YAMADA NEWS

No. 08-008E

Design Change for DIAPHRAGM PUMP

NDP-20 Series
NDP-25 Series

Diaphragm

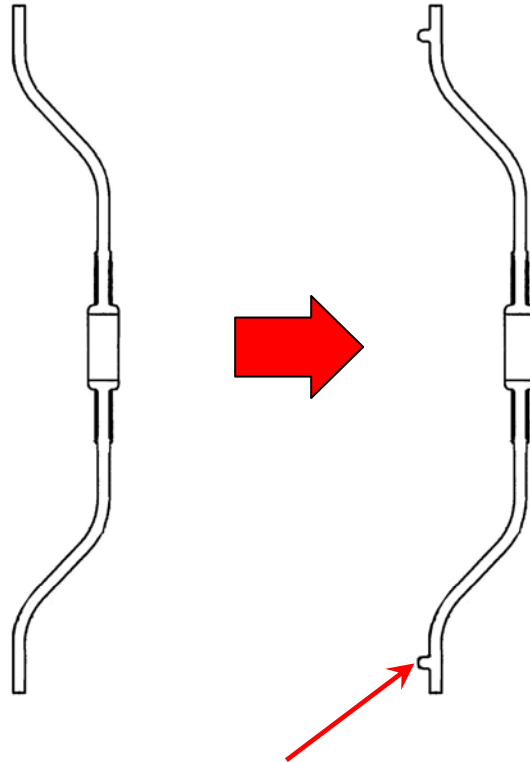
***This change applies to
NDP-20/25 B□C, B□N, B□E and B□V
ONLY***

NEW Diaphragm has a bead

NDP-20		
<i>Material</i>	OLD		NEW
CR	771254	➔	772957
NBR	771255		772958
EPDM	771256		772959
FKM	771257		772960
	NDP-25		
<i>Material</i>	OLD		NEW
CR	771258	➔	772961
NBR	771259		772962
EPDM	771260		772963
FKM	771261		772964

New Diaphragm must be used with New Air chamber.

Additional O-Ring

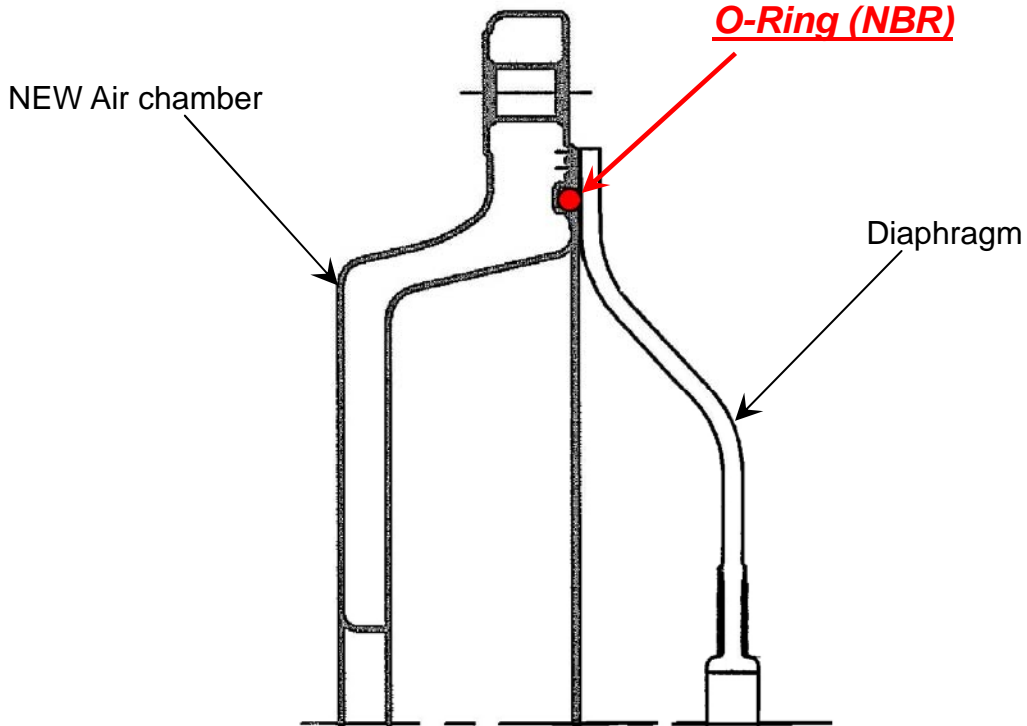
***This change applies to
NDP-20/25 B□T, B□H and B□S
ONLY***

Part No.	Description	Qty
710275/711504	AIR CHAMBER	2
	DIAPHRAGM	2

Part No.	Description	Qty
715937/715938	AIR CHAMBER	2
	DIAPHRAGM	2
640151	O-RING	2

Part No.	Description	Qty
710276/711220	AIR CHAMBER	2
	DIAPHRAGM	2

Part No.	Description	Qty
715939/715940	AIR CHAMBER	2
	DIAPHRAGM	2
640154	O-RING	2

O-Ring must be used with New Air chamber.
